BD DESIGNS PRIVATE LTD

Observations

Hairline Crack on a Beam at 5th Floor Ceiling

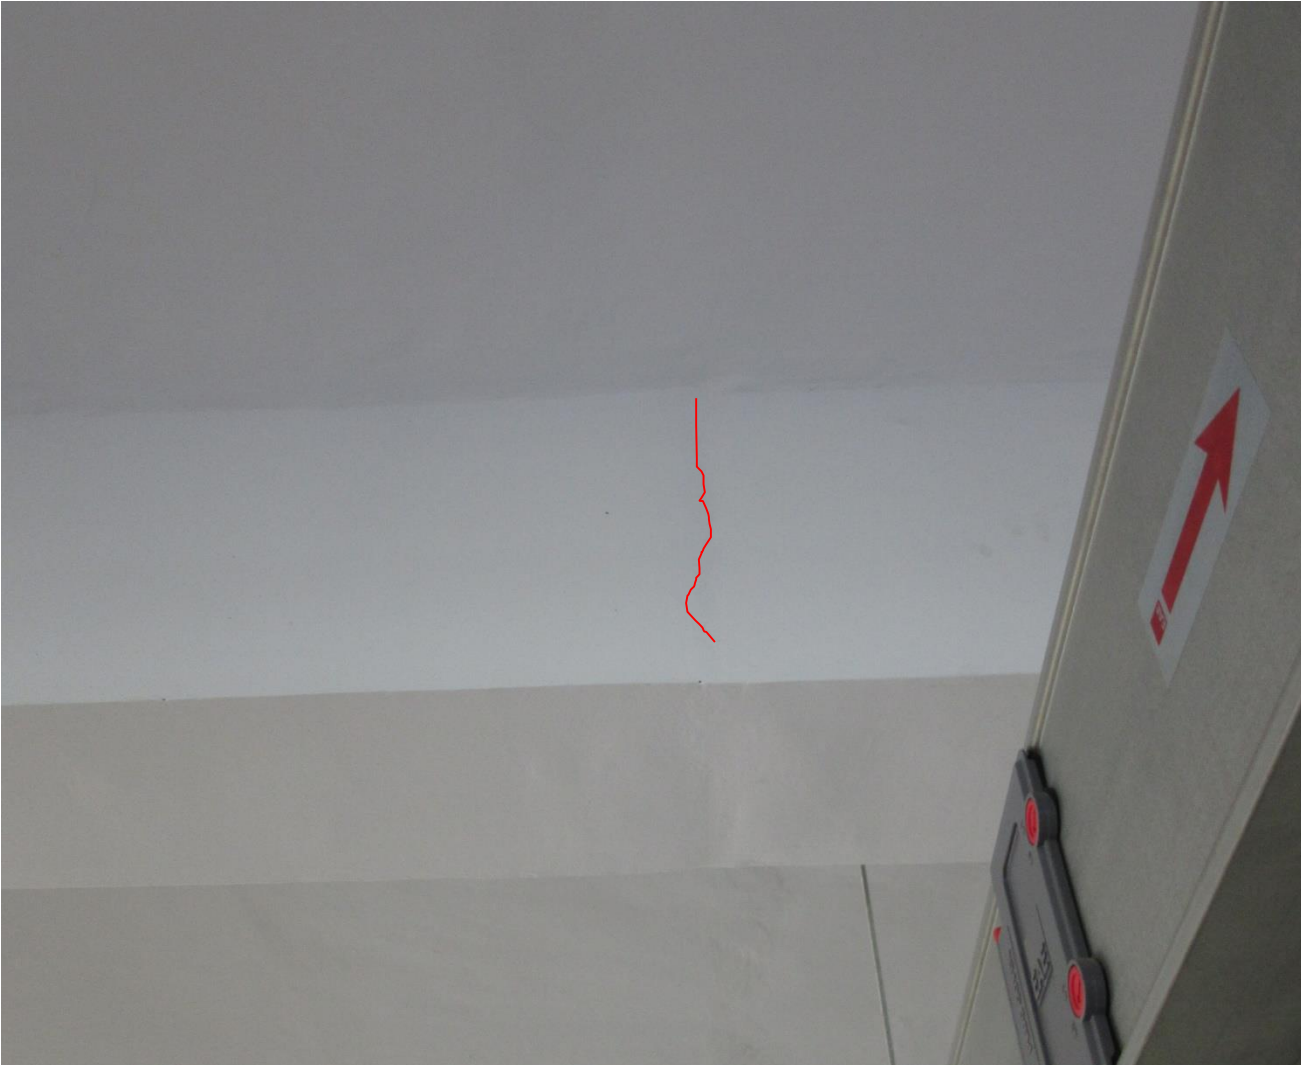
Hairline crack observed on a beam at 5th floor ceiling.

Item No.	Observation	Recommended Action Plan	Recommended Timeline
1	Hairline Crack on a Beam at 5th Floor Ceiling	Building Engineer to get the crack properly repaired.	6-months
2	Hairline Crack on a Beam at 5th Floor Ceiling	Building Engineer to monitor the repaired beam to check if new cracks occur.	6-months
3	Stability of the Canopy at East Side of the Building	Stability and the connection details of the canopy at the East side of the building to be checked by the Building Engineer.	6-months
4	Stability of the Canopy at East Side of the Building	Make necessary alterations to the structural members of the canopy, if required.	6-months
